ILLINOIS POWER COMPANY

December 3, 1981

Clinton Power Station Unit 1
Docket No. 50-461

In order to address the issues raised by Questions 220.14, 220.15, 220.121, and 220.26 we met with the NRC staff on October 15, 1981. It was agreed in that meeting that a site specific spectrum for the Clinton site will be developed and used for a new soil spring SSI analysis. The effort to develop the site specific spectrum is in progress and is expected to be completed by early January 1982. Based on our initial evaluation it was determined that a 0.17 g Regulatory Guide 1.60 spectrum will envelope the site specific spectrum for Clinton.

Figure 220.15-1
TYPICAL SUBSURFACE PROFILE

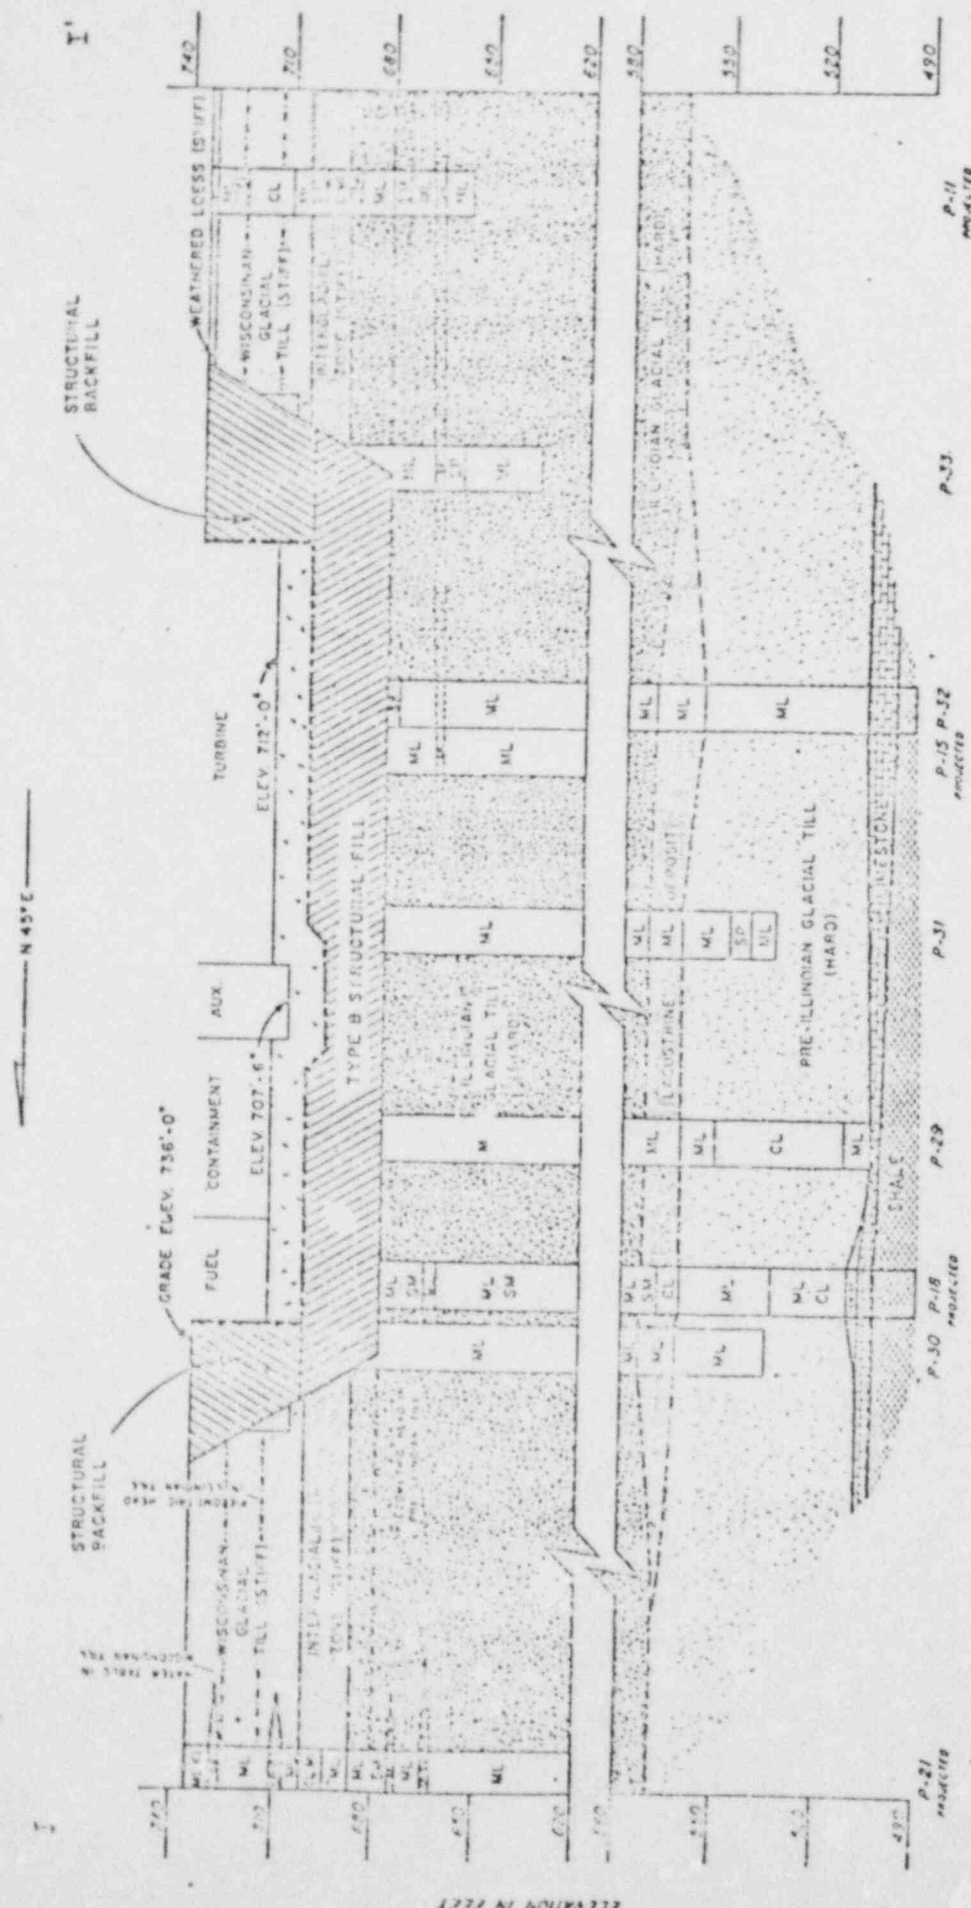
Our examination of Figures 3.7-12 through 3.7-27 indicate that at some frequency the free-field foundation level spectra is considerably less than the design response spectra as defined in FSAR, Section 3.7.1.1. Such reduction in design response spectra at foundation level is not acceptable to the staff. Either provide justification or use free-field motion at foundation level.

Indicate how this motion accounts for variation in the soil properties at the site.

Typical Subsurface profiles underneath the plant structures is shown in Figure 220.15-1. It can be seen from this figure that the plant structures are underlain by 20 feet of structural fill followed by 105 feet of Illinoian Till. The Illinoian Till layer is underlain by Lacustrine Deposit and the Pre-Illinoian Till followed by bed rock. The dynamic soil properties considered for the design basis analysis is presented in FSAR Table 2.5-48. To determine the appropriate upper and lower bound of dynamic soil properties for use in the new soil spring soil structure interaction analysis, the dynamic triaxial test results on samples from each of the deposits underlying the plant were replotted and evaluated. Based on this evaluation the upper and lower bound soil dynamic shear modulus, ^{values} were determined and are presented in Figures 220.15-2 through 220.15-5 for the structural fill, Illinoian Till, Lacustrine Deposit and Pre-Illinoian Till layers respectively. These upper and lower

FIGURE 220.15-6
SOIL STRAIN RANGE FOR STRONG MOTION EARTHQUAKES

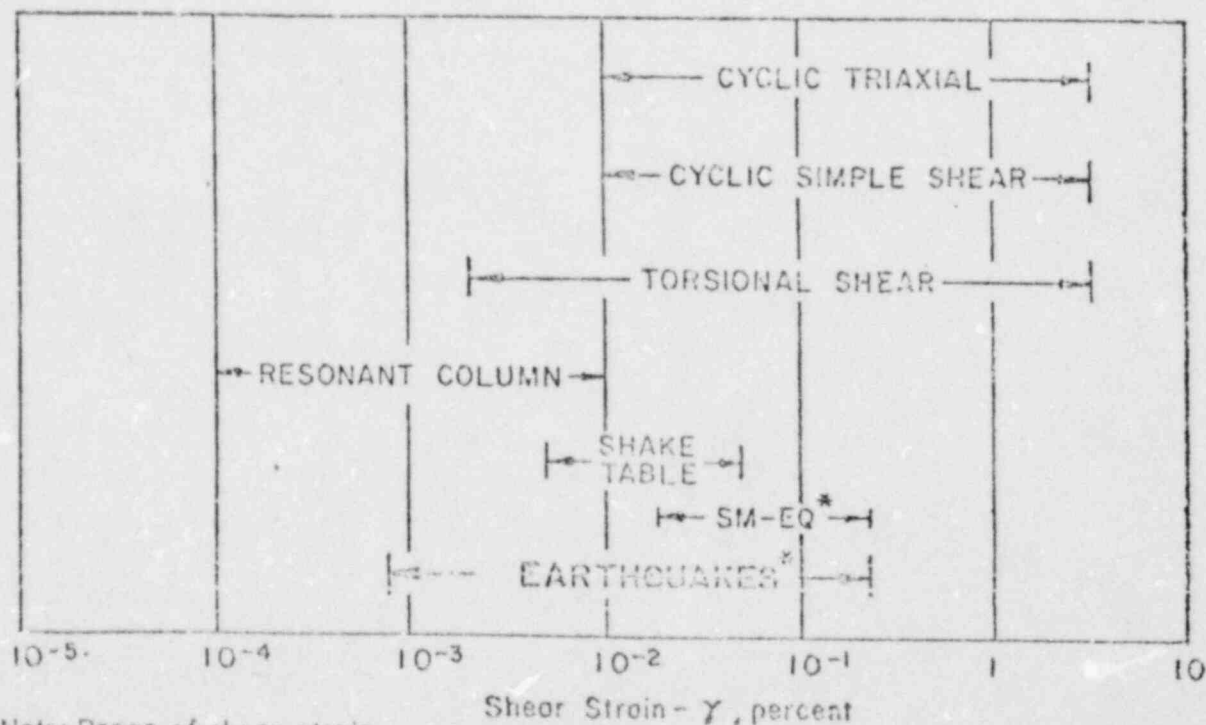
You have stated that strain-compatible shear modulus and damping values for each layer for both OBE and SSE earthquakes are obtained from "SHAKE" analysis. Indicate, for each layer, to which strain-levels these values correspond to. In addition, give numerical values of these soil properties and corresponding strain levels. Provide this information for both vertical and horizontal analysis. In the staff's opinion, the soil properties used in the soil-structure interaction analysis should be those corresponding to the low strain levels, which are consistent with the realistic soil strain developed during the design earthquake. Use of high strain parameters need to be adequately justified. Discuss, how did you account for variation in material properties in your soil-structure interaction analysis.

The soil shear modulus is dependent on the maximum effective shear strains expected during the SSE. The range of soil strain expected during strong motion earthquakes is presented in Figure 220.15-6 which is reproduced from Reference (2). This range varies from 1.5×10^{-2} to 1.5×10^{-1} percent strain. For the Clinton SSI analysis a low 2.0×10^{-2} percent strain level is considered. As lower strain levels lead to higher shear modulus values and higher shear modulus values lead to higher structural response, the 2.0×10^{-2} percent shear strain level is considered to be conservative.
